STAFF ANALYSIS

Case No.: CZ-20-1243619 **Agenda #:** N. 7

Location/Address: 1816 Candler Road **Commission District:** 03 **Super District:** 07

Request: A major modification to remove zoning conditions CZ-89033, CZ-90052, and CZ-91039 to allow for mixed use development, Candler Crossing, in the Interstate 20 Corridor Compatible Use Overlay District.

CONCEPTUAL SITE PLAN

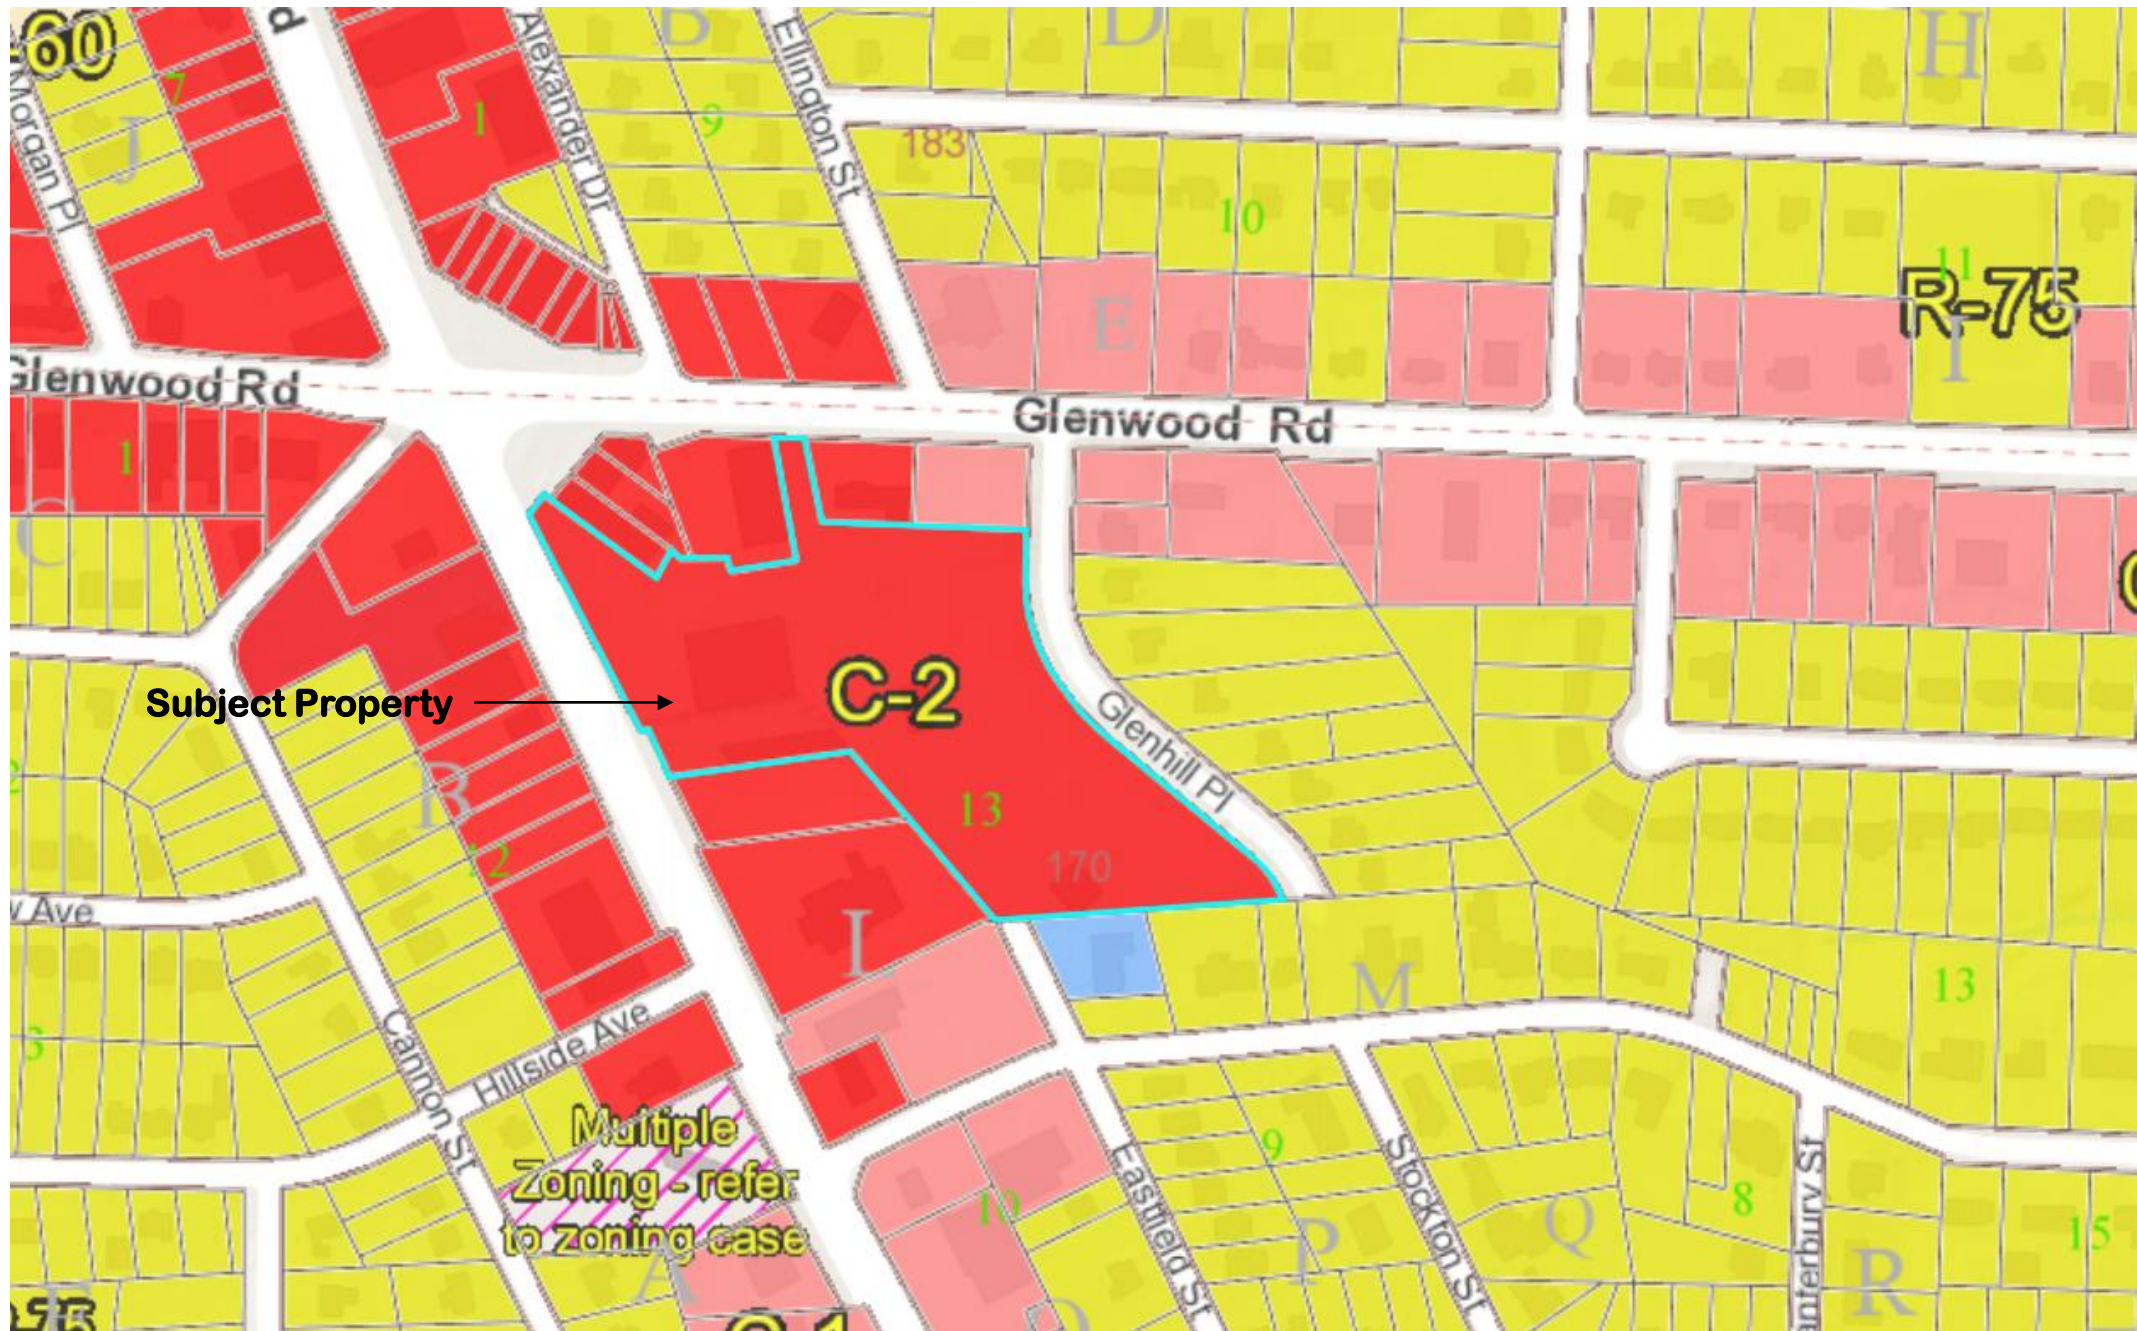
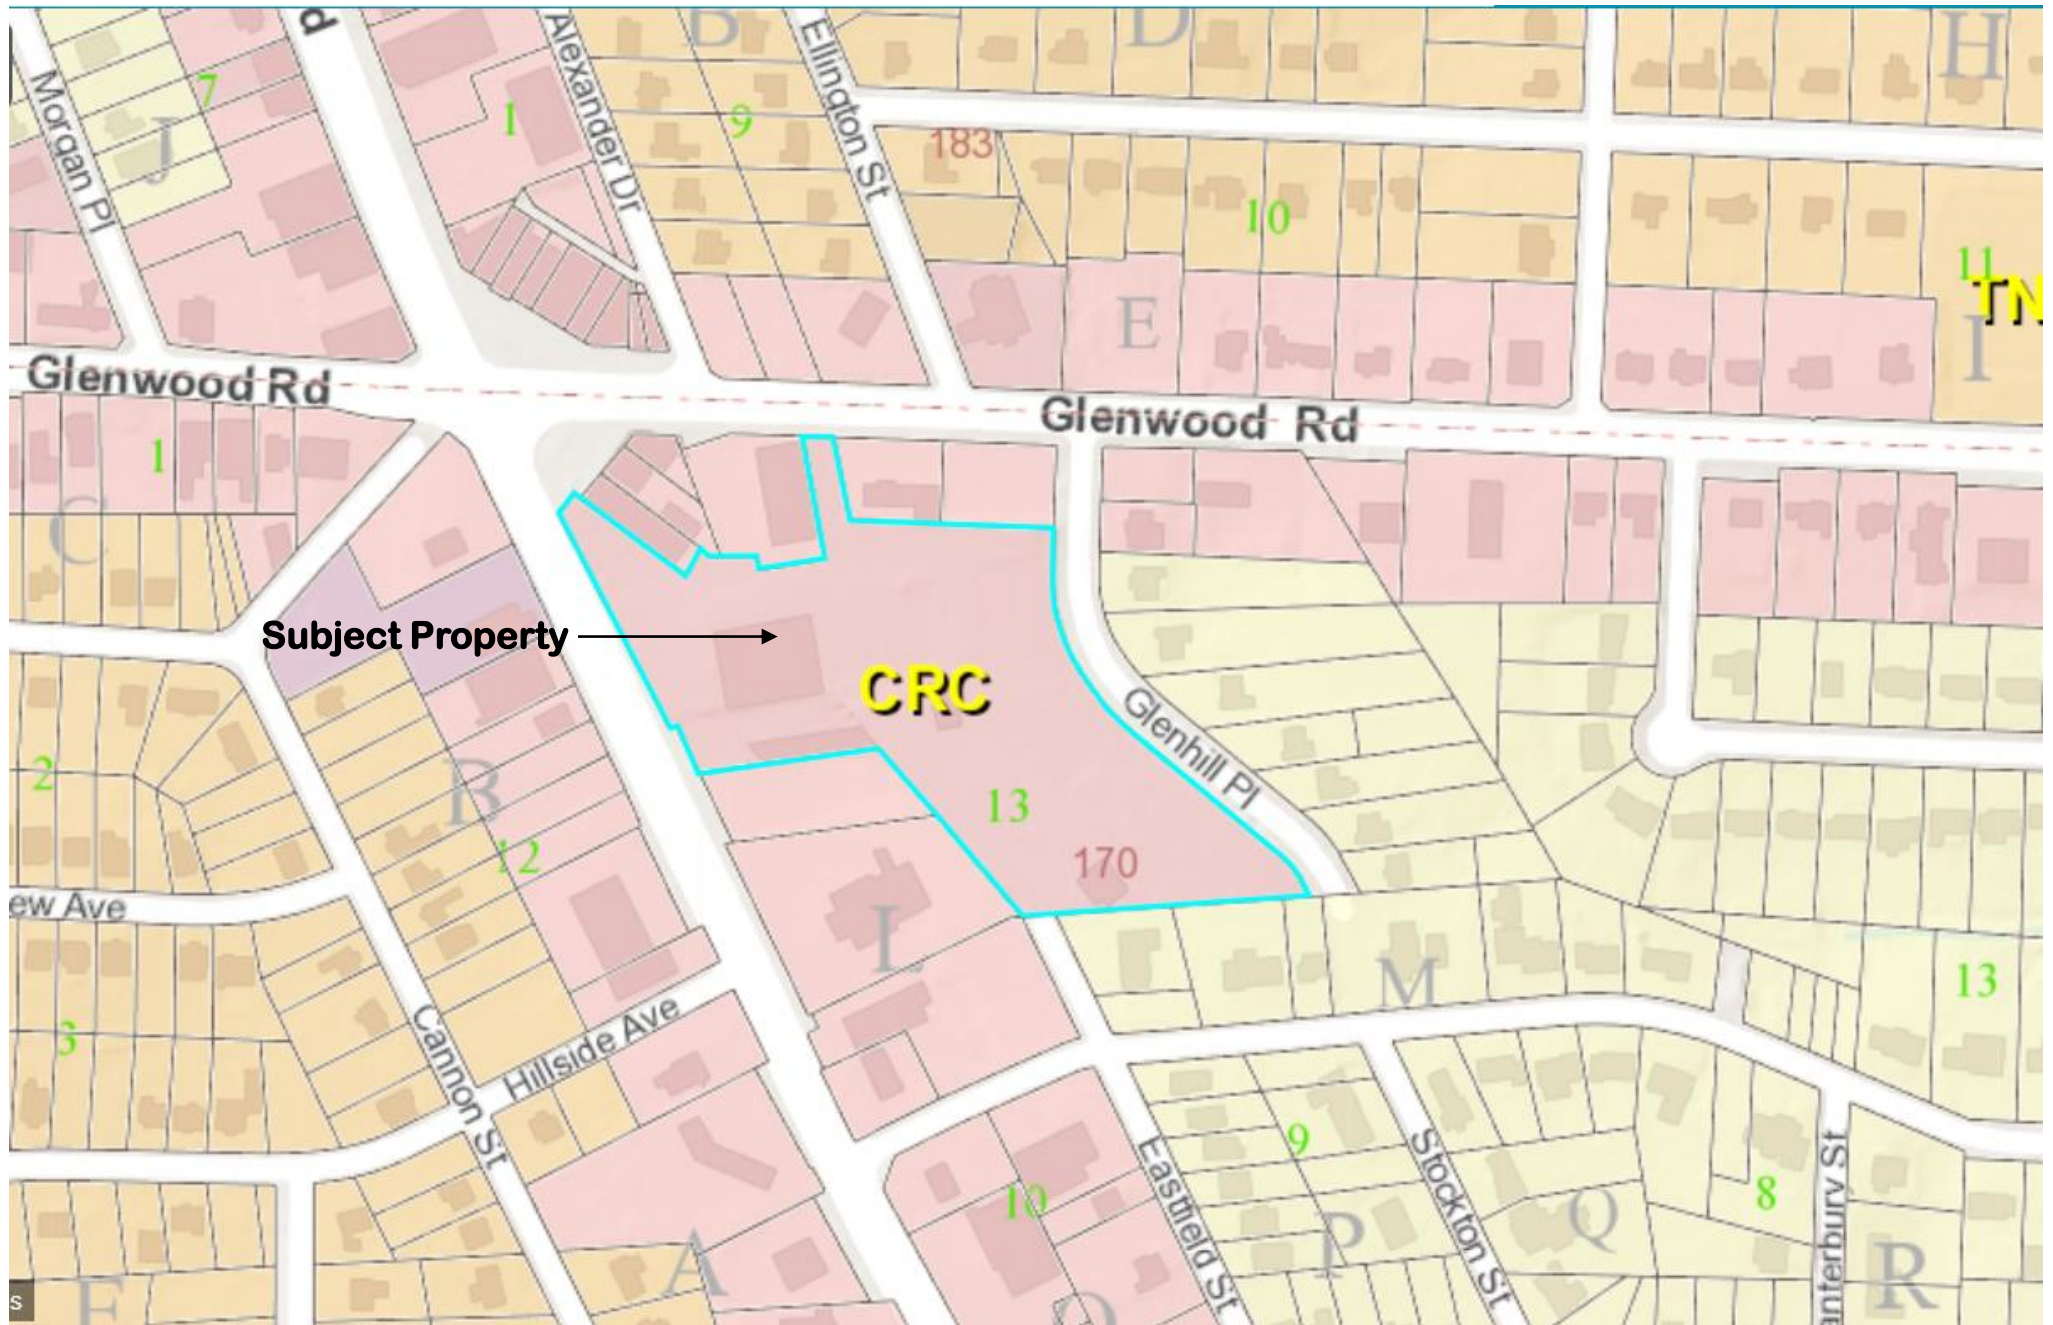
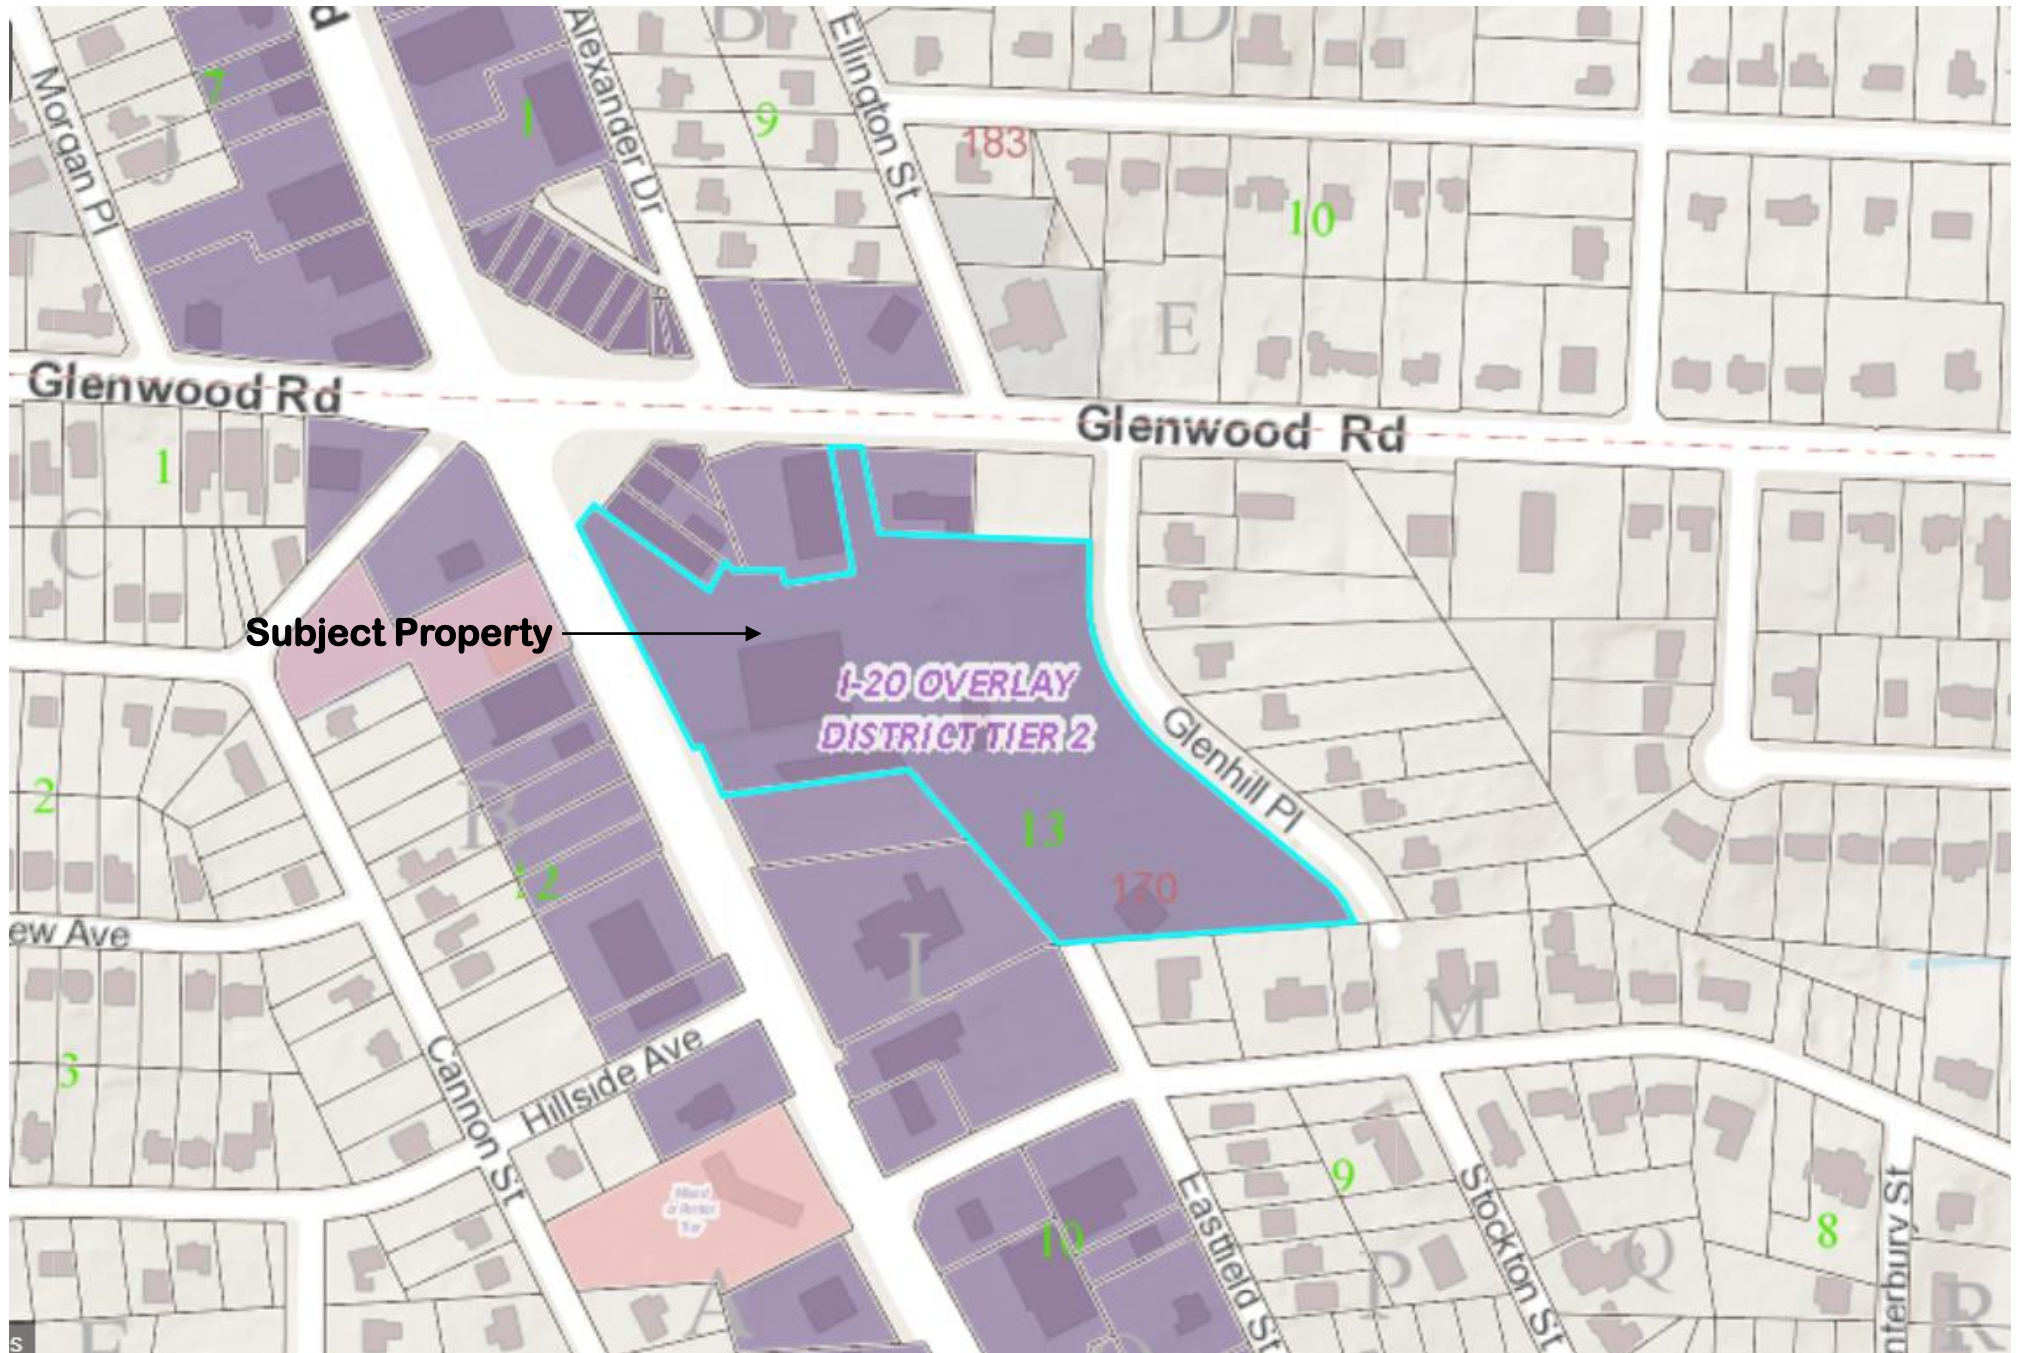
ASSTO guidelines must be submitted with permitting. Per the submitted site plan, access is proposed on Glenhill Place.

The DeKalb County Planning and Sustainability Department – Land Development Division provided the following comments: Stormwater management is required per Chapter 14-40; A hydrology report with a detention pond. The submitted sketch does not show detention pond or indicate if it is underground. The volume generated by this new development will require a dedicated lane into or possible exiting the development to the intersection.

Storm water management is required as per Chapter 14-40, over 5000 square feet of impervious.

The report shall have a Hydro report with a detention pond. The sketch submitted shows no detention pond, or indicated if it is underground.

The Volume of traffic generated by this new development will require a dedicated lane into or possible exiting the development to the intersection.

1. Must comply with the Interstate 20 Corridor Compatible Use Overlay District with plans that show building setbacks, height of building and structures, density, density bonus (if applicable), required parking, open space calculations, transitional buffer zone and transitional height, elevations complying with architectural regulations and landscaping requirements. Variances may be obtained from appropriate regulatory authorities.
2. Access to and from Glenhill Place shall be prohibited.
